CM CLARIFICATION #004

PROJECT: CNE Tahlequah Casino

ADDENDUM # 001

Tahlequah Casino Addendum #01 summary

S2.1

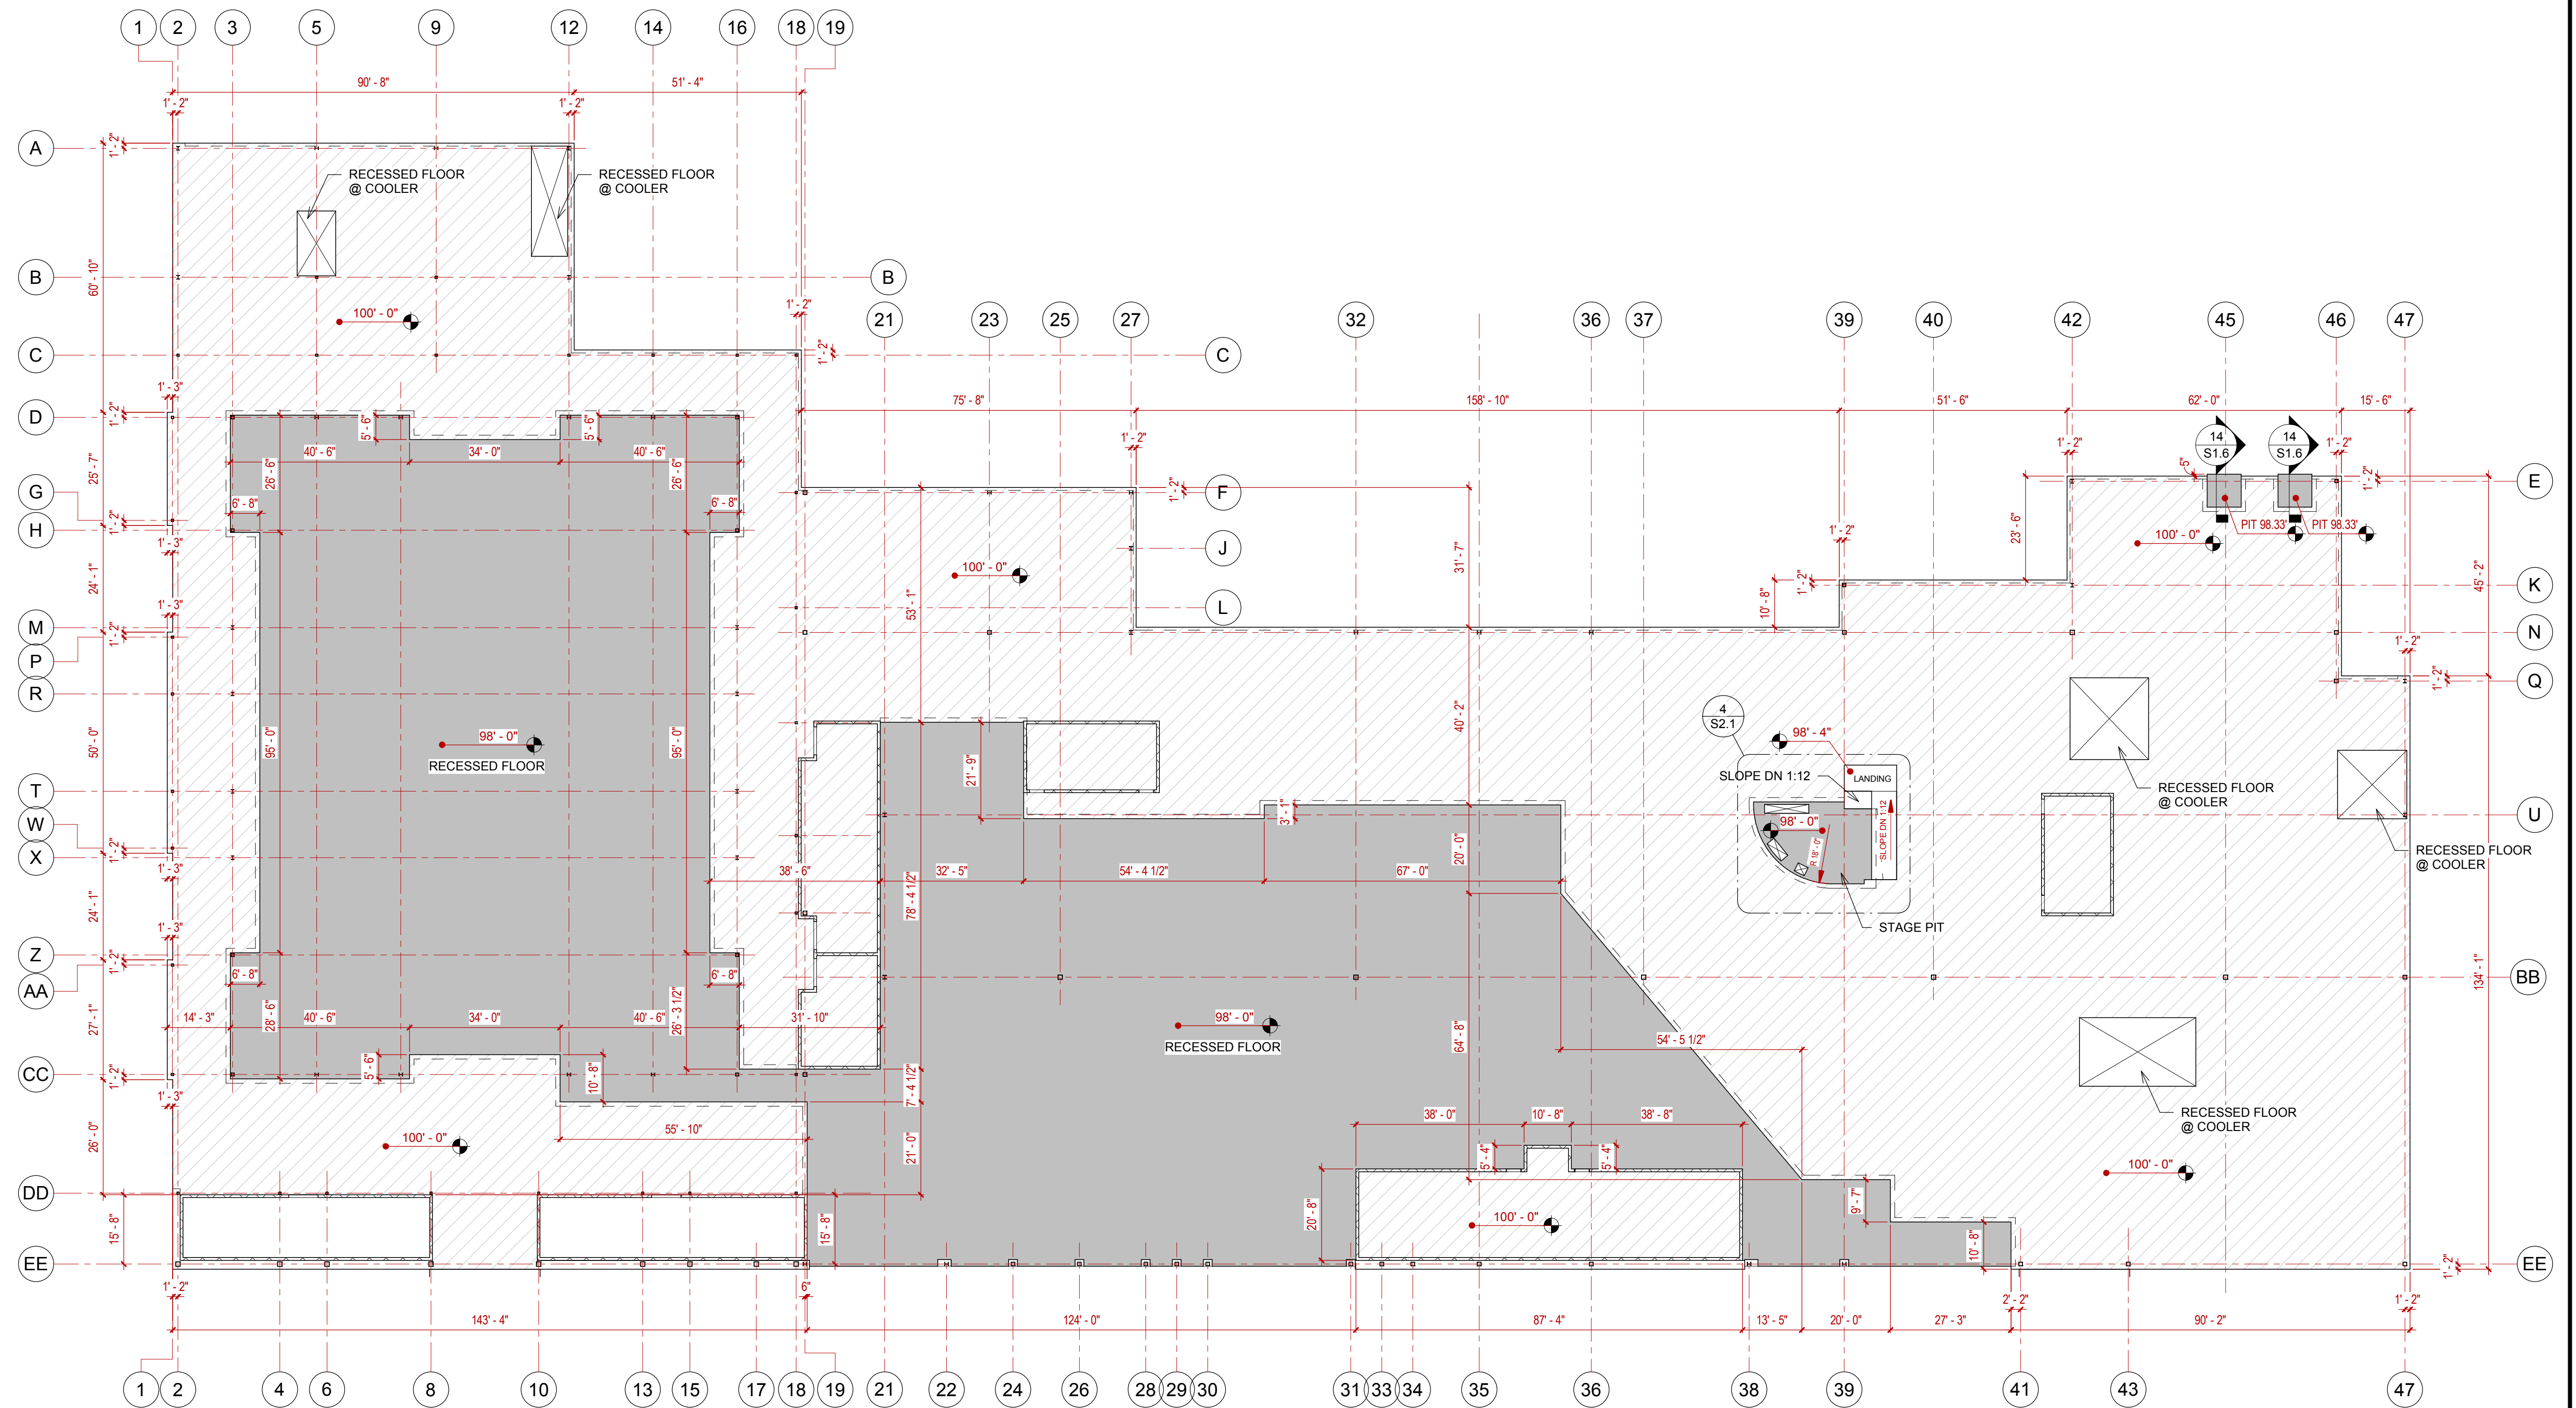
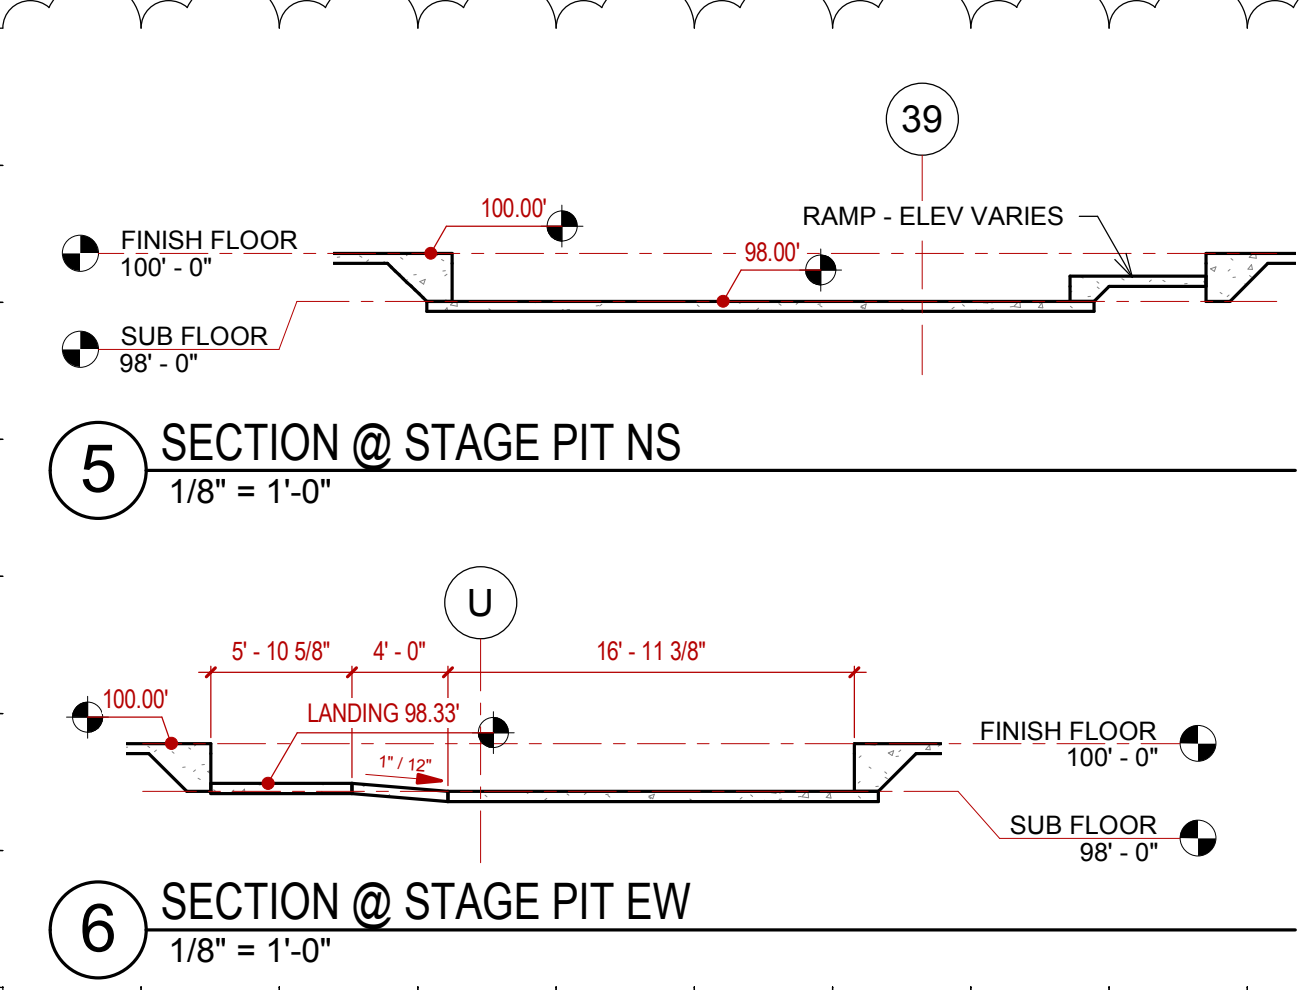
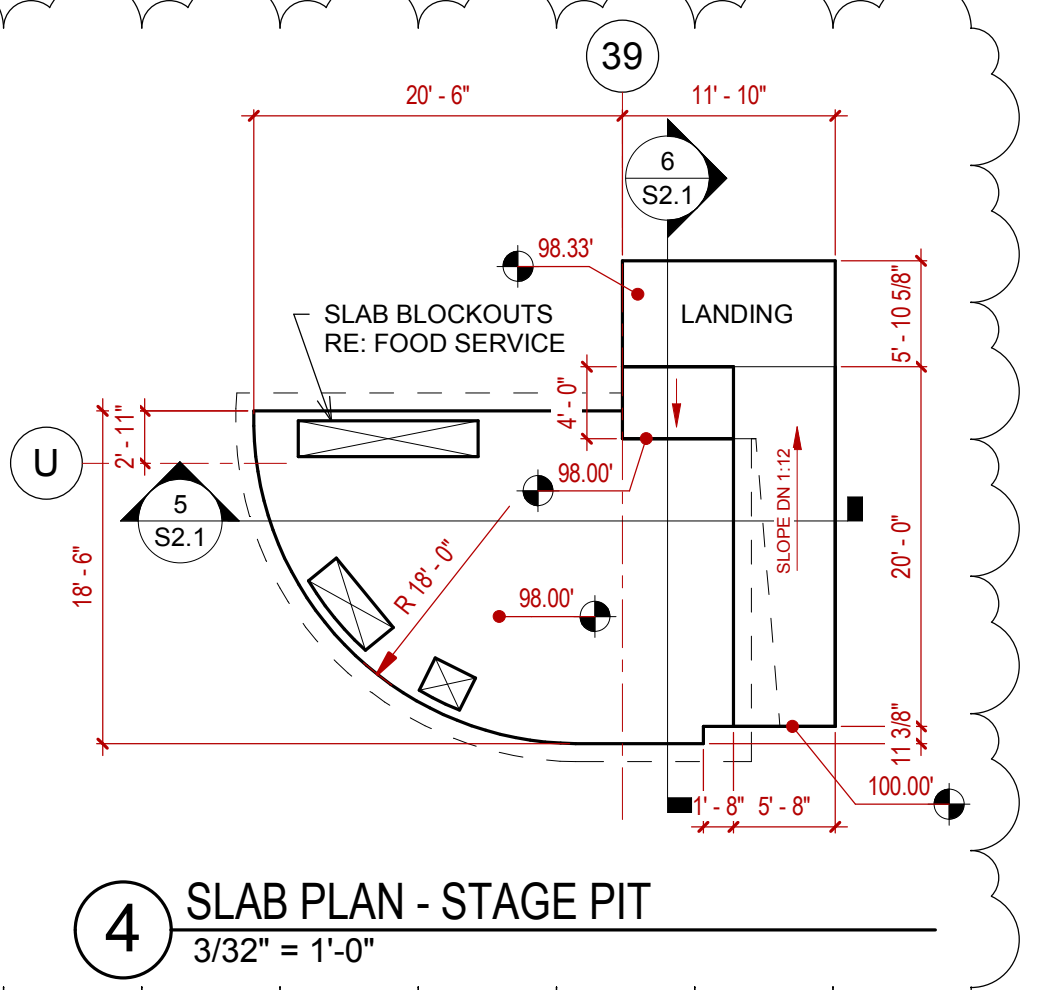
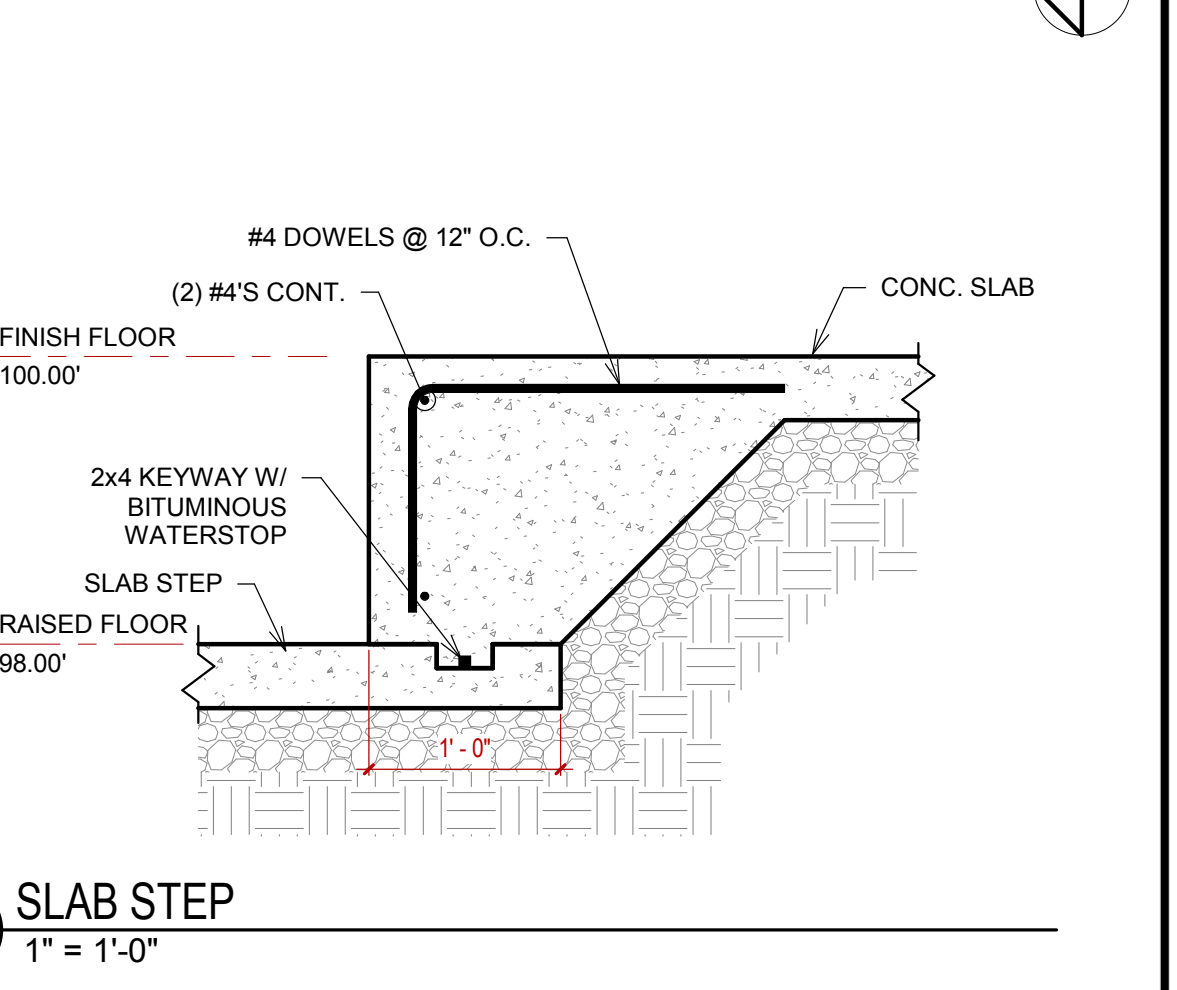
S1.5	Added sheet S1.5
S1.6	Added sheet S1.6
S1.7	Added sheet S1.7
S2.1	<ul style="list-style-type: none"> • Added enlarged stage pit plan and sections. • Added pit for dock levelers.
S3.1	<ul style="list-style-type: none"> • Revised roof deck to galvanize. • Revised column sizes.
S3.2	<ul style="list-style-type: none"> • Moved brace elevation from Y/BB-19 to U/BB-21 • Moved frame line 'DD' 1" east • Revised roof deck to galvanize. • Removed column @ U-19 & U-27.
